# Clash Gour Airspace Change Proposal

## ACP-2021-046

### Stage 2 Stakeholder Engagement Document

Date: 9th June 2022  
Revision: Issue 1  
Ref: 71609 020

Figure 1 - Proposed TMZ on LOS Radar Display

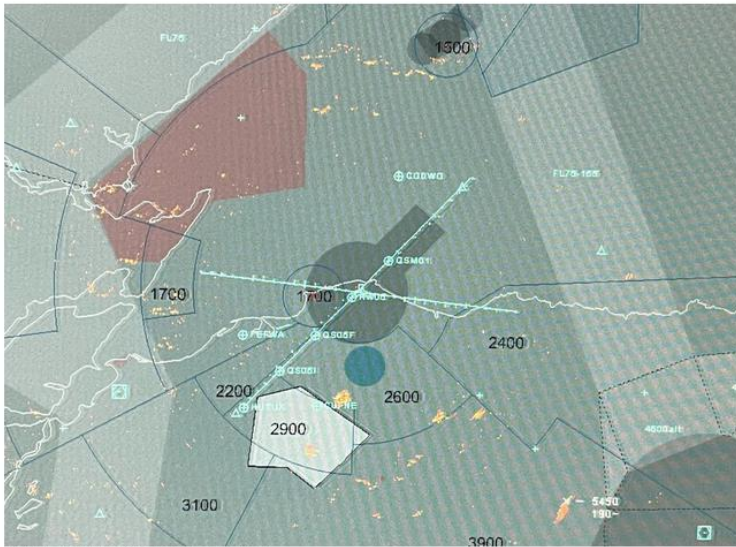
Figure 1 depicts the Lossiemouth AoR with one of the proposed RAG blanked/TMZ area to the south plotted (note this is rough plotting, no guarantee of accuracy). The extended centrelines and RNP procedure map overlays are visible, as well as the Easterton Gliding area (blue circle south of the MATZ). Existing Wind Turbine developments already create a challenge when operating IFR to the south of LOS (clutter visible) for approaches to RWY05, with 2x developments already in situ in the vicinity of the proposed Clash Gour. One of the existing areas of clutter would be covered by the proposed TMZ however the other would not as it is just on the NE edge between TMZ and Easterton.

The presence of the overland TMZ and associated blanking potentially in such close proximity to (and potentially overlapping) existing published IFR arrival/departure procedures may be unacceptable to MOD and they will therefore be seeking further guidance about what is permissible under current regulations and policy. However, if it were to be deemed acceptable, the dimensions of the area must be simple in shape and contain a buffer (size would need to be safety assessed to agree).

Any blanked area and associated TMZ would need to be checked against WAM coverage to ensure there are no gaps or areas of poor coverage that would render aircraft invisible to the controller. As WAM is not yet in service, this is difficult to verify; however, when there is greater clarity on the option(s) to be proposed at stage 3 of the ACP then a request can be made to the relevant authority. An assessment on the performance of the STAR NG radar would also need to be made, to identify the likely impact of the wind turbine on the sensor and what is required to mitigate it, whilst remaining within the bounds of its Release to Service and not undermining the Terminal ATC Operating Safety Case. In the event of a loss of WAM (planned or unplanned maintenance, random failures etc.) the blanking would mean any aircraft operating in the TMZ would not be shown and therefore an ATC Service could not be applied. Operating IFR to runway 05 when Primary (STAR NG) only, is a safety concern to Lossiemouth.

All IFR approaches to RWY05 will be impacted (PAR, TACAN, SRA) and the blanked area would limit Surveillance Radar Approaches to a northerly feed-in, which would limit flexibility and reduce the effectiveness of the service being provided. The TMZ location would funnel non-cooperative traffic to the north, which would put it into conflict with traffic on IFR approaches to RWY05, as well as IFR departures from RWY23, whereas without the TMZ they can freely route to the south of the approach/departure lane. It will also impact RNP procedures (not yet published but in progress), the TACAN Hold for RWY05 and likely to impact ATS provision for departures on the MID23 South. It should be noted that any impact to Lossiemouth procedures may have a knock-on impact to Inverness ATC procedures.

Formation stream departures and arrivals would be affected if any ac has an unserviceable transponder, as track ident of each formation element would not be possible through the TMZ. This would mean avoiding the TMZ to the south which then brings higher terrain into the equation, which is not acceptable for fast jet recoveries where fuel is often at a premium. The TMZ also impacts overall traffic flow in the AoR to the south of Lossiemouth, with potential funnelling of non-transpondering traffic into the 05 approach/23 departure lane, further exacerbated by location of Easterton. Occasionally, Typhoons general handle, south of Lossiemouth whereby SSR often drops out (due manoeuvring), this may further limit where fast jets can freely operate. All of these factors would mean an increase in ATC workload, especially if Lossiemouth were to be the authority for the airspace.
